Release Note

Edgecore EWS5204 Release v3.52.0001

Document # Edgecore_EWS5204_ERN_v3.52.0001

Enhancement from v3.45.0401

1.3 Add "Select Product Type" in template using WAPM

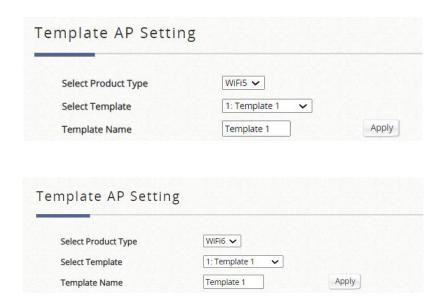
In template page of WAPM, add the two options in "Select Product Type" field, WiFi5 and WiFi6. WiFi5 is compatible with WiFi 5 access point. WiFi6 is compatible with WiFi 6 access point.
